MARK	DATE	DESCRIPTIONS	BY	CH'D	CCO#
2	01/31/07	CORROSION PROTECTION	JD	AS	16
1	07/21/06	W2 CAP BEAM ISD	JD	NV	23

SAN FRANCISCO OAKLAND BAY BRIDGE
EAST SPAN SEISMIC SAFETY PROJECT
SELF-ANCHORED SUSPENSION BRIDGE
(SUPERSTRUCTURE & TOWER)

W2 CAP BEAM POST-TENSIONING DETAILS NO. 5

TOP TENDON LAYOUT PLAN ("E" Line)

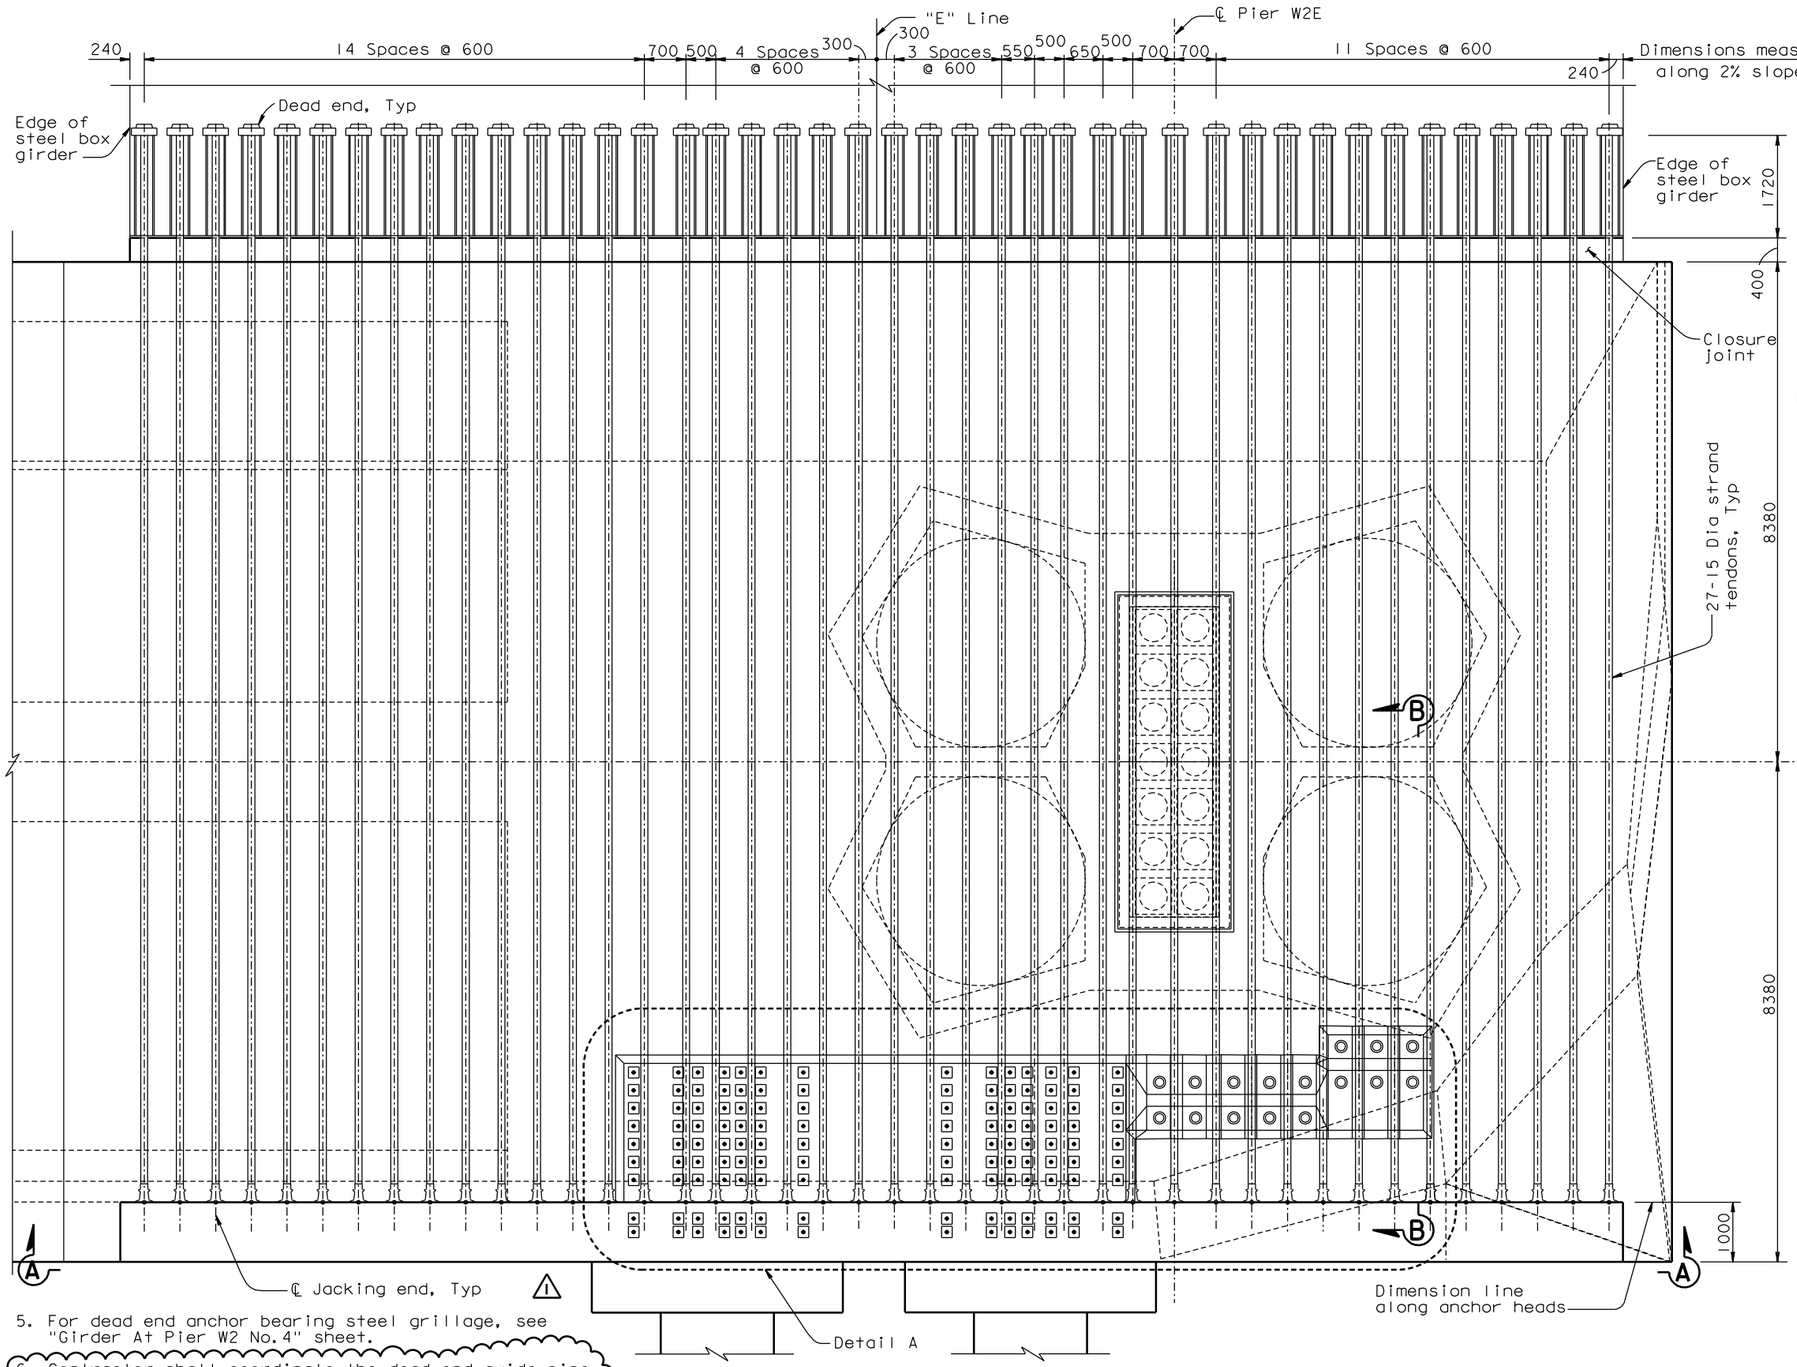
6. Contractor shall coordinate the dead end guide pipe details with the PT System Supplier and shall submit them to the Engineer for review and approval. Contractor shall grout the guide pipe after stressing operations have been completed. (2)
